# **AGENDA**

## **HISTORIC LANDMARKS COMMISSION**

**April 17, 2018**

NC17-06 New Construction NC17-06 by Chester Trabucco to construct a 6,832 square foot, single story commercial building at 632 Marine Drive in the S2-A Tourist-oriented Shorelands Zone.

(Similar to Fisher Building) W Elevation

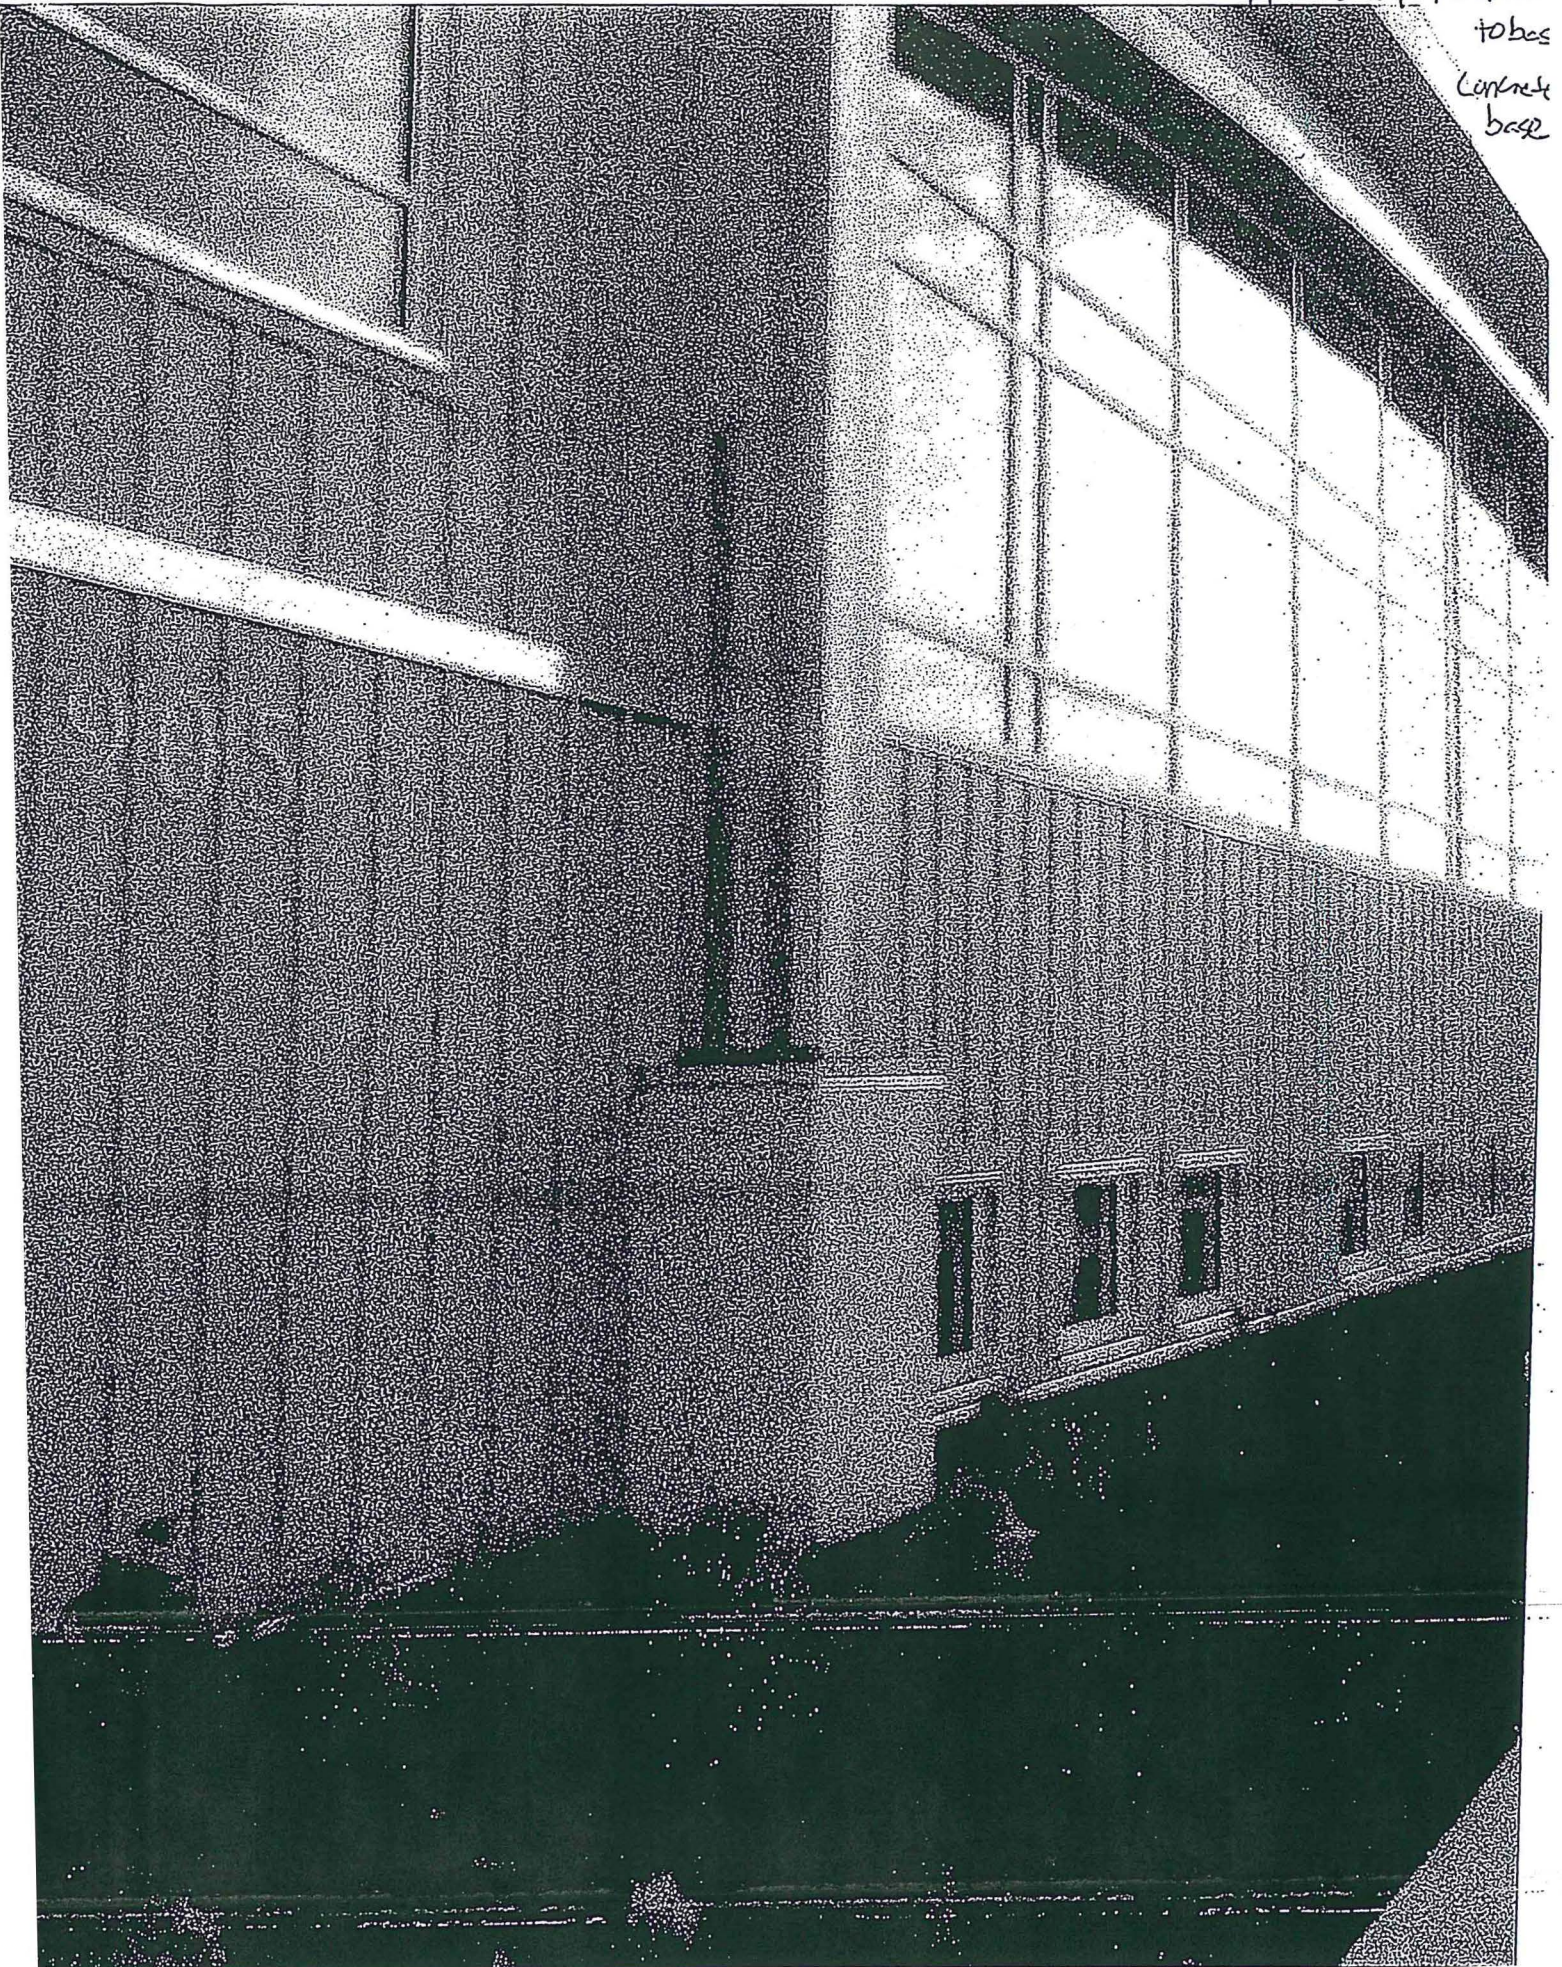
Wood wrapped will go further down  
to be  
Concrete  
base

1 PROPOSED NORTH EXTERIOR BUILDING ELEVATION  
SCALE: 1/4"=1'-0"

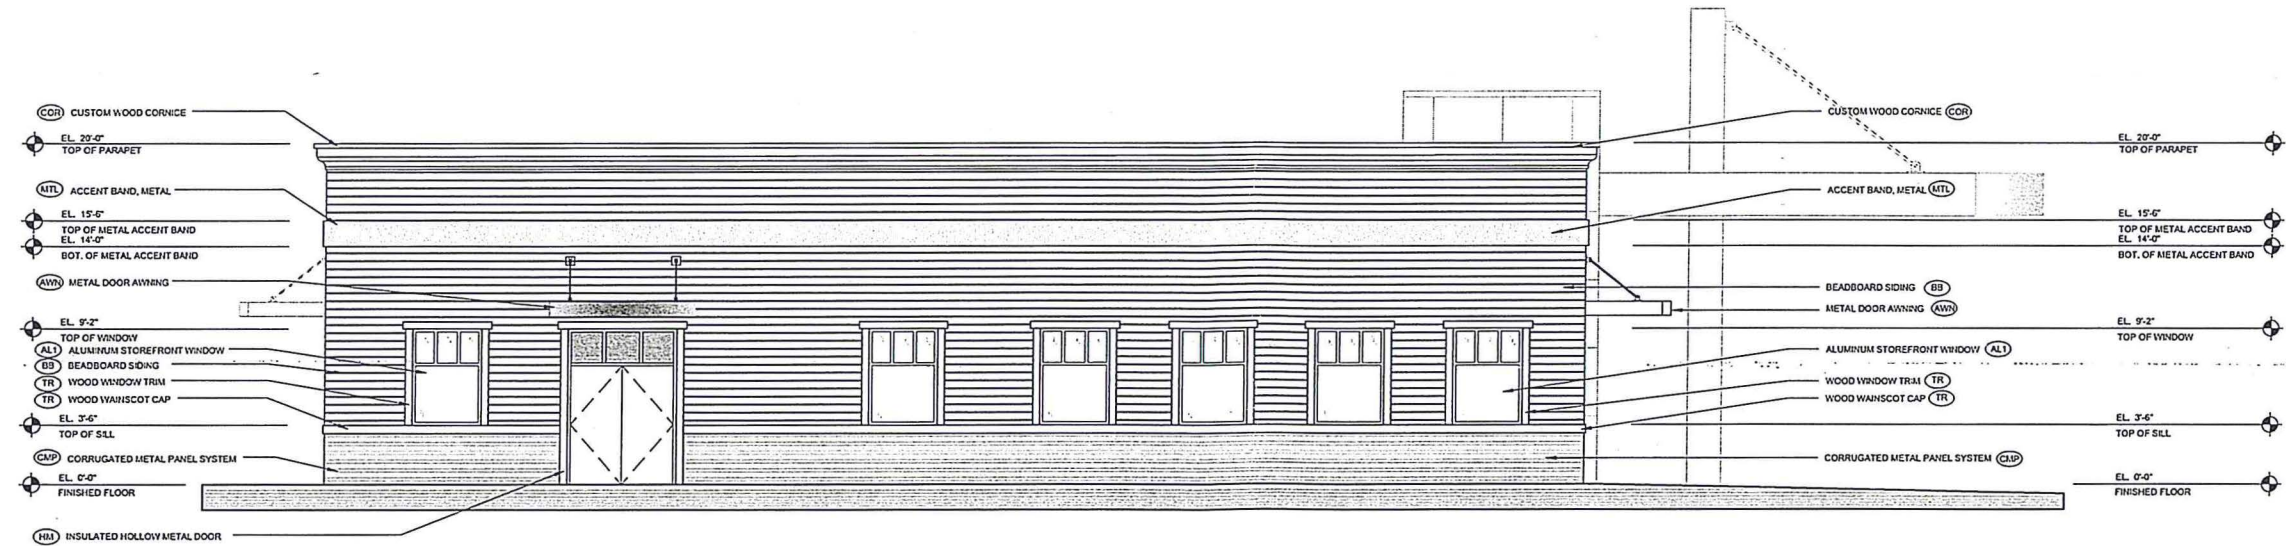
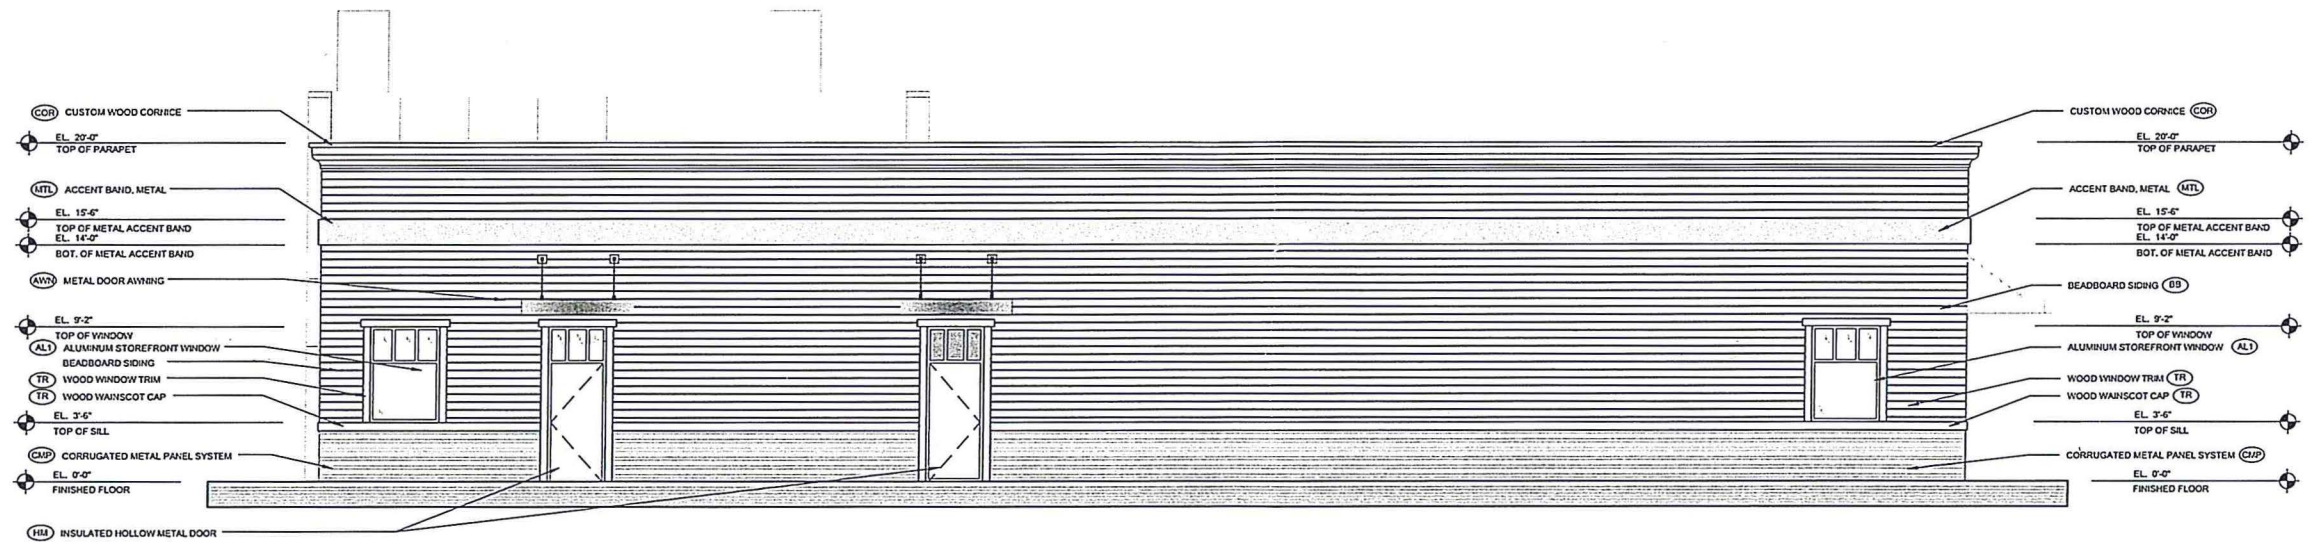
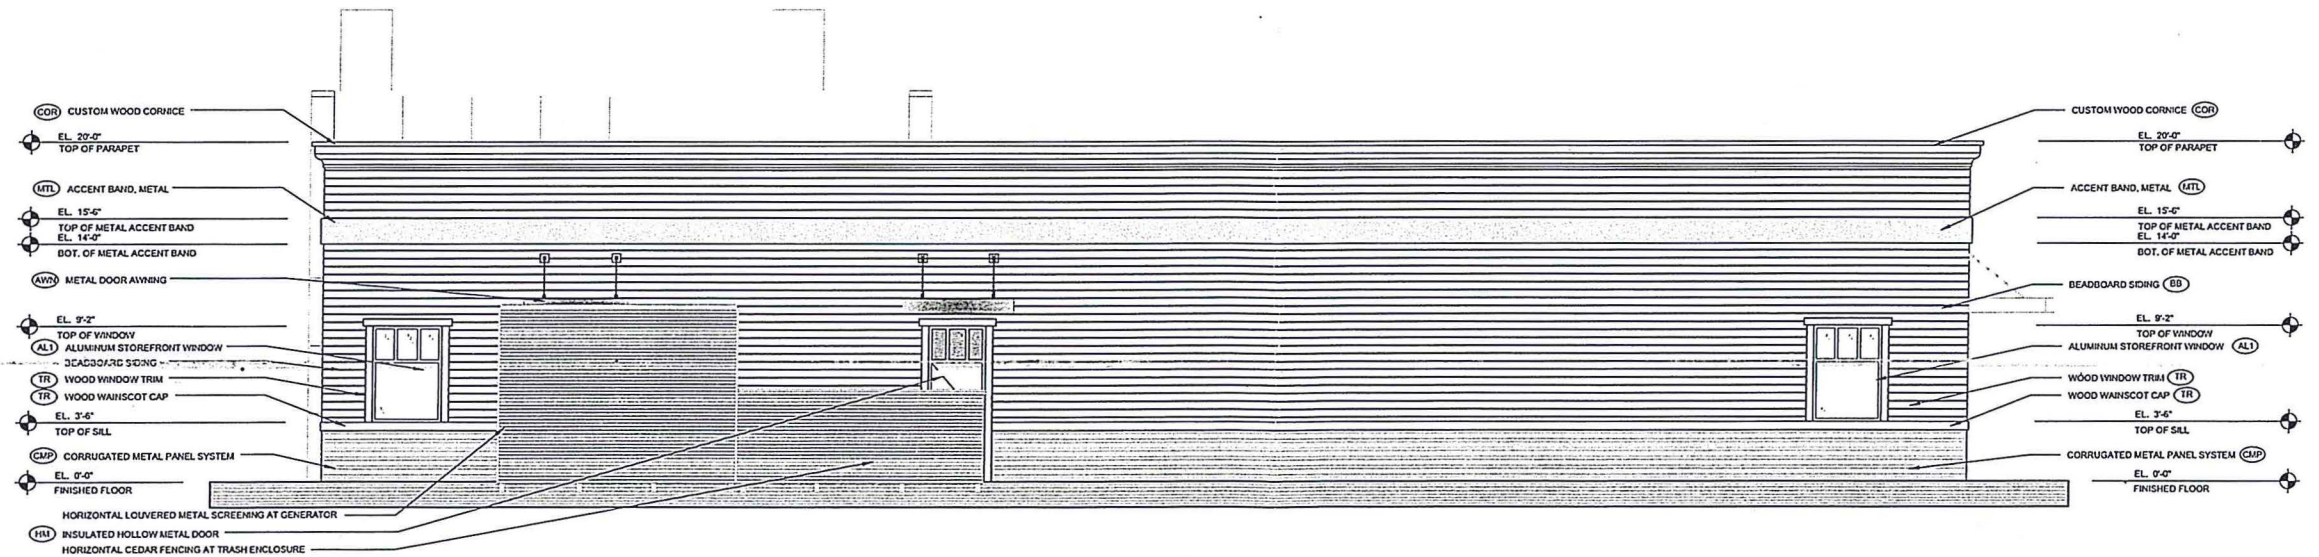
Planner Ferber understood the Commission was also concerned about the landscaping plan for the north side, additional details on the windows and trim, the concrete base, the transition between the concrete base and the siding, details on the belly band, receiving scaled drawings, design details underneath the rooftop cornice at the corners, and the exact location of the trash enclosure.

Vice President Dieffenbach said scaled drawings would show whether or not the scale was appropriate and the mass needed to be broken up. The building looked fine, but she wanted to see scaled elevations with the proper height of the building, windows, doors, and porte-cochere. The Commission could review the scaled drawings and materials for the bottom band at the next meeting. She was fine with the landscaping and was not worried about what went into the landscaping plan as long as it looked good.

President Gunderson noted the trash enclosure would be 6' tall and the generator would be 11' feet tall. However, the drawing showed them both at the same height.

The design submitted 4/6/18 now includes a new smooth metal paneling system around the porte cochere, and taller columns rising above the canopy to 27' 8". The base of the building has also been updated to a corrugated metal panel system going up 3'6" to the bottom sill of the windows.
